METRORAIL TRAFFIC SAFETY ASSESSMENT

Prepared For:
Metropolitan Transit Authority of Harris County

March 11, 2004

Figure 4. Possible new sign to be mounted on median on SB Fannin at Ewing.

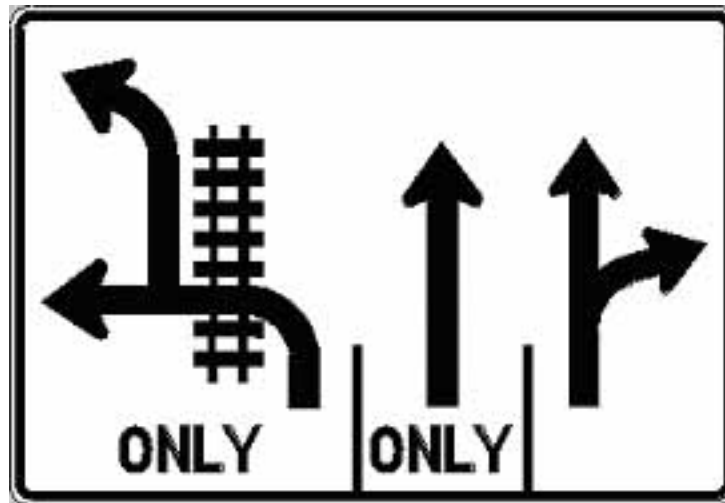
- Change directional lane assignment sign currently located on divider island to illustrate ALL lanes of travel, including all through lanes on Fannin; sign should be simplified to contain no street names (see figure 4).

Figure 5. Possible new mast arm sign just south of Ewing over left SB Fannin lane to Hermann Drive.

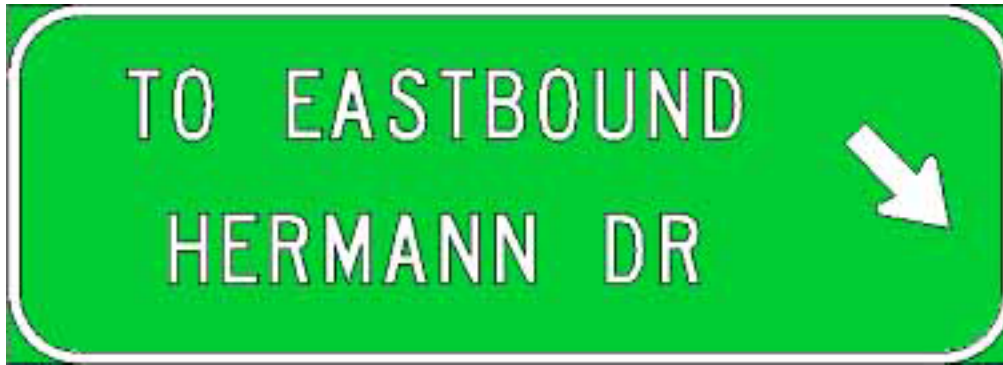
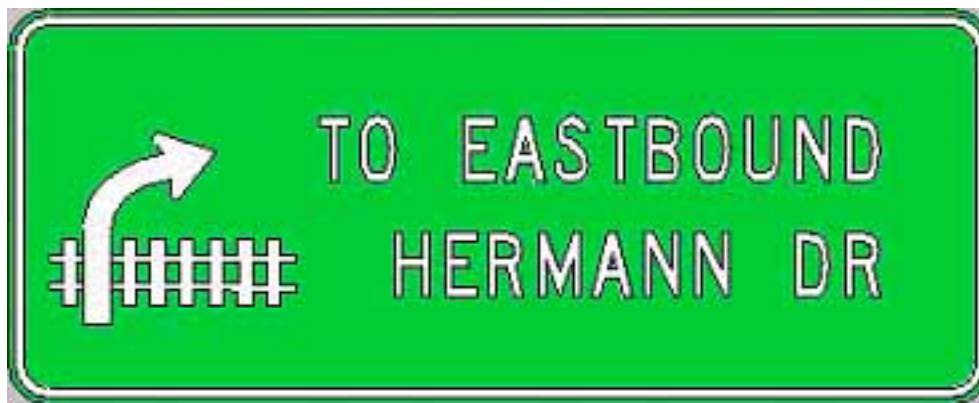
- Remove small white on green direction information sign facing west from pole in southeast corner of intersection; replace with larger signs as shown in Figures 5 and 6.
